INSTRUCTION TO SERVICE

ITS: 60596		December 21, 2022
SECTION:	350-Driver's Controls	
WRITTEN BY:	Troy Stutsky	
SUBJECT:	Movement in Steering Column to Upper Steering Drive Shaft Joint	
ISSUE:	An under torque on the pinch bolt between the steering column & upper steering drive shaft has caused movement and wear in the joint.	
SUMMARY:	Torque existing hardware to specification and inspect joints. Remove the steering column & upper steering drive shaft & replace parts if required.

Ref. NHTSA Recall No.	Ref. Transport Canada Recall No.
22V-943	2022-732

Figure 1: Locations to Torque on Steering System

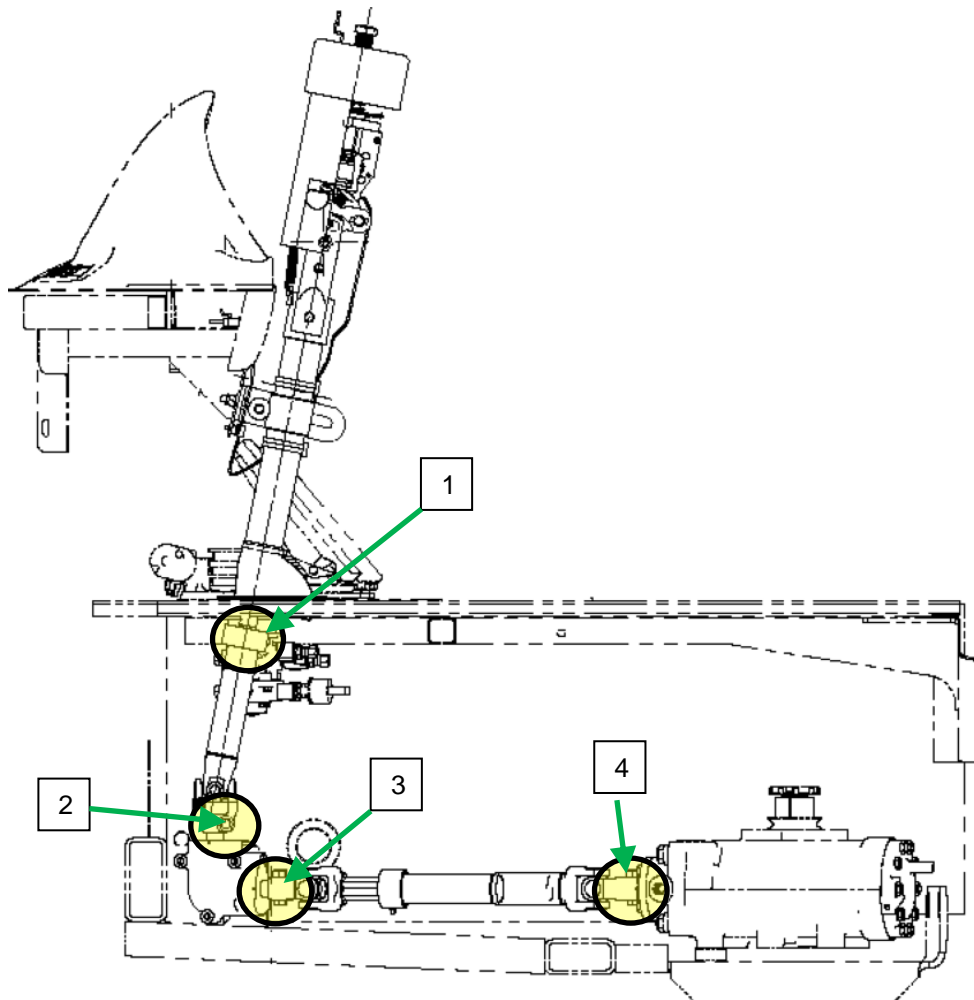
1. Set park brake and chock wheels.
2. Turn the main battery disconnect switch to the “OFF” position.
3. On the steering assembly of the bus with the steering assembly still installed in the bus, please torque the hardware in the four locations shown in Figure 1 to $70\pm 4\text{Ft/Lbs}$ dry. Please ensure that the bolts are $7/16'' - 20 \times 2.00''$; Grade 8; Zinc (NF PN 6444255) & the nuts are $7/16'' - 20$; Self Locking; Zinc (NF PN 6444254). If any 10MM hardware is found in any of these four locations it should be removed and replaced. Remove existing torque witness marks and re-mark after new torque has been applied.

4. After the new torque has been applied, inspect for any free play at the splined, torqued joint between the steering column and the upper steering drive shaft, which is identified as Area #1 in Figure 1, by grasping the drive shaft mid-length and applying a lateral force. There should be no free play in this torqued joint. If no free play has been found, the bus is safe to return to service.

5. If free play is found at the splined, torqued joint between the steering column and the upper steering drive shaft, which is identified as Area #1 in Figure 1, please proceed to remove the steering column & upper steering drive shaft from the bus for closer inspection on the shop bench.

Figure 2: Upper Steering Shaft Measurement

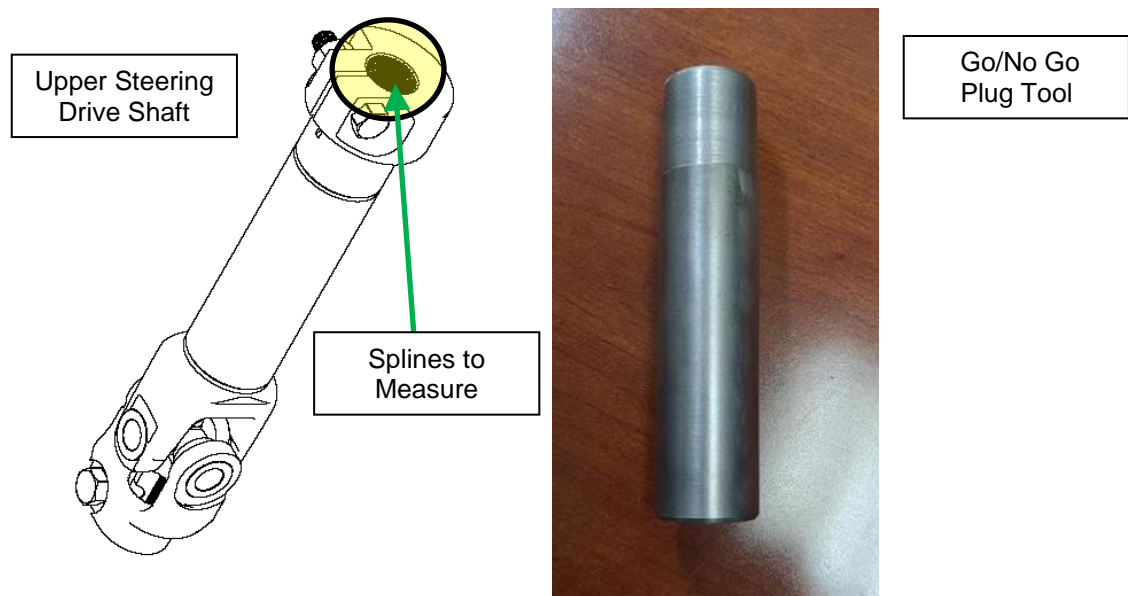
7. Using the PSS Go/No Go Plug tool measure the solid, splined end of the upper steering drive shaft. See Figure 2.
 - a. If the Go/No Go Plug **will not fit** into the splined portion of the drive shaft, the upper steering drive shaft is a pass and can be reused as required.

- b. If the Go/No Go Plug **does fit** into the splined portion of the drive shaft, the upper steering drive shaft is a fail and will need to be safely stored for using in a welded assembly if required.

Figure 3: Steering Column Measurement

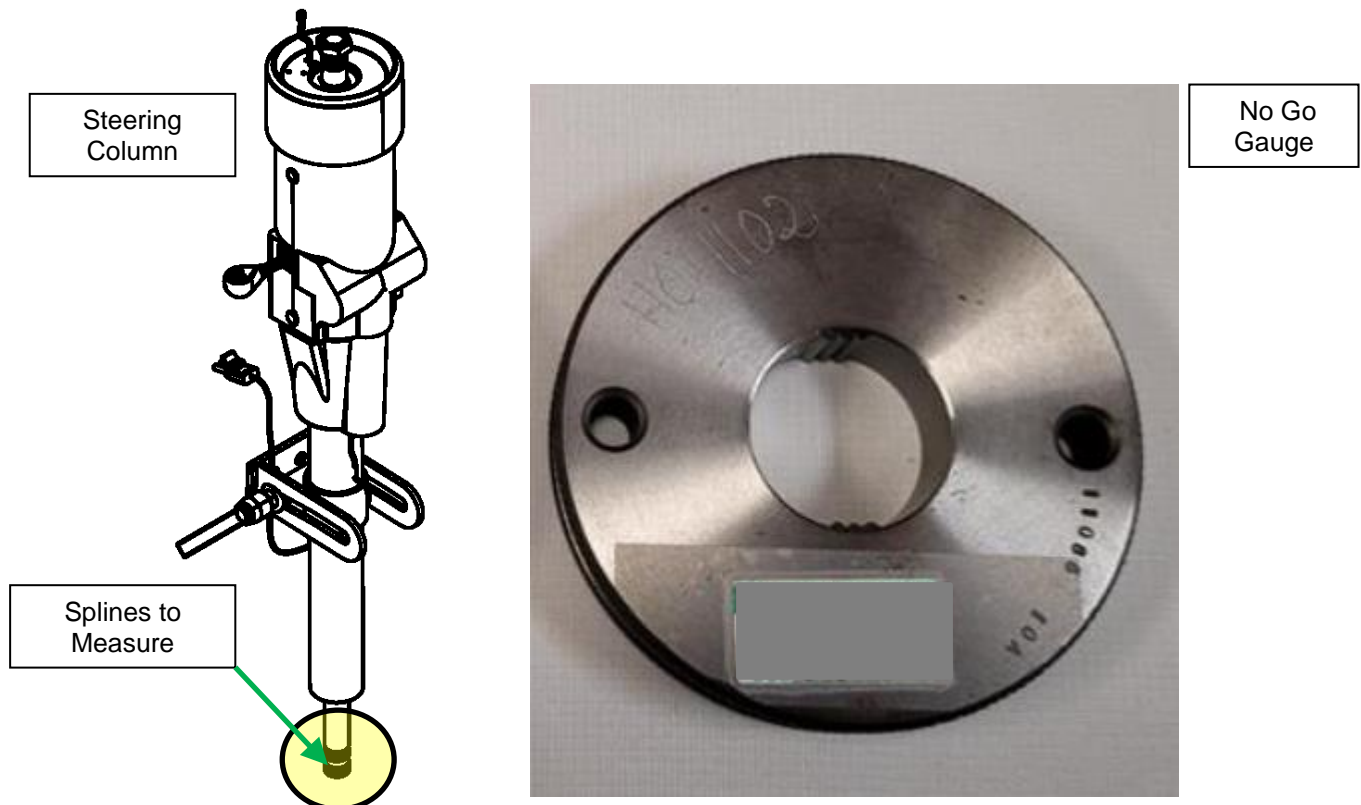
8. Using the No Go Gauge measure the splined end of the steering column. See Figure 3.
 - a. If the **No Go** Gauge **will not fit** over the splined portion of the steering column, the steering column is a pass and can be reused as required.
 - b. If the **No Go** Gauge **does fit** over the splined portion of the steering column, the steering column is a fail and will need to be safely stored for using in a welded assembly if required.

Photo of steering column connection under review in this report.

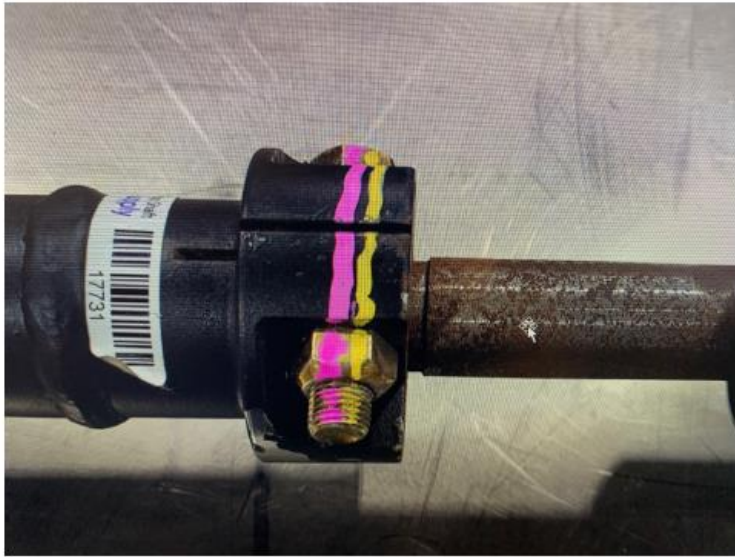
This weld procedure is written in response to the request to reinforce a splined connection in a New Flyer steering column with weld metal. The splined connection has been reported to have deteriorated, necessitating the exploration of a welded connection. A photo of the connection under review is shown below.

The driveshaft component (at left on photo above) is reported to be fabricated out of 1141 steel, which is a steel formulated with high sulfur content to aid in machining. The steering column (at right on photo above) is reported to be fabricated out of 1018-1020 steel. These materials were identified by the specific suppliers of these parts to New Flyer specific to coaches built for Seattle.

A review of the maximum torque of the steering column suggests that a 5/16" all around fillet weld could be used to transmit the torque through the joint.

Welding of 1141 steel requires consideration for the high amount of sulfur. It is required that a lower heat input process be used to minimize base metal dilution, as well as allowing for a slow cooling rate to allow the sulfur containing compounds to fully freeze during the time of solidification and weld shrinkage. An electrode with a higher Mn content is recommended to be used as a mechanism to tie up sulfur in MnS compounds so that less is available to form the more deleterious FeS compounds. It is recommended that the GMAW weld process be used with a 0.045" diameter ER-80S-D2 electrode.

3. Pre-heat the steel to 200 degrees F to a distance of no less than 3" away from the zone to be welded, in any direction.
4. Using the GMAW weld process with a 0.045" diameter ER-80S-D2 electrode, first weld the seam on the driveshaft side so that the fillet weld has full backing about the circular fillet weld. Tack welds may be used to secure the driveshaft to the steering column. Once the backing weld has been placed, proceed to weld the circumference of the weld joint with a 5/16" fillet weld. Weld in the flat or horizontal positions.
